SUBJECT: ISSUANCE OF AMENDMENT (TAC NO. M79289)

The amendment revises the TMI-1 Technical Specifications to reflect planned reracking of the "A" Spent Fuel Pool to allow additional storage capacity.

Amendment No. 164
License No. DPR-50

SAFETY EVALUATION BY THE OFFICE OF NUCLEAR REACTOR REGULATION
RELATED TO AMENDMENT NO. 164 TO FACILITY OPERATING LICENSE NO. DPR-50

Figure 5-4 Relationship between Initial Enrichment and Acceptable Fuel Burnup (Spent Fuel Pool A - Region II)

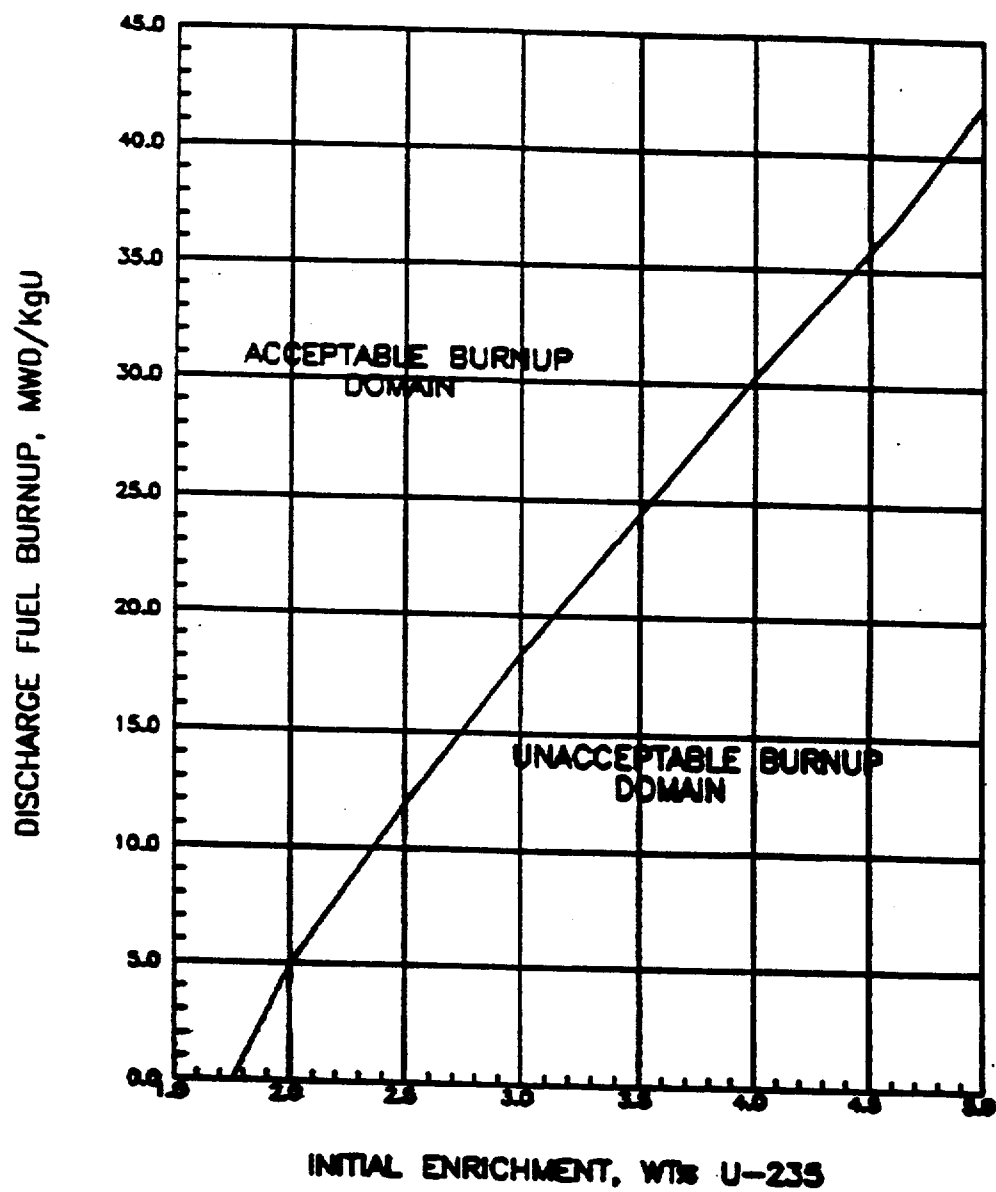
- (4) TS 5.4.2.g and Figure 5-4 are added to provide administrative controls to limit storage of spent fuel assemblies in Region 2 of the SFP A storage racks based on initial enrichment and cumulative exposure.

- * The "B" pool fuel storage racks are designed using the floor response spectra of the Fuel Handling Building.
- f. Fuel in the storage pool shall have a U-235 loading equal to or less than 57.8 grams of U-235 per axial centimeter of fuel assembly.
 - g. When spent fuel assemblies are stored in Region II storage racks of the Spent Fuel Pool "A", the combination of initial enrichment and cumulative burnup for spent fuel assemblies shall be within the acceptable area of Figure 5-4.
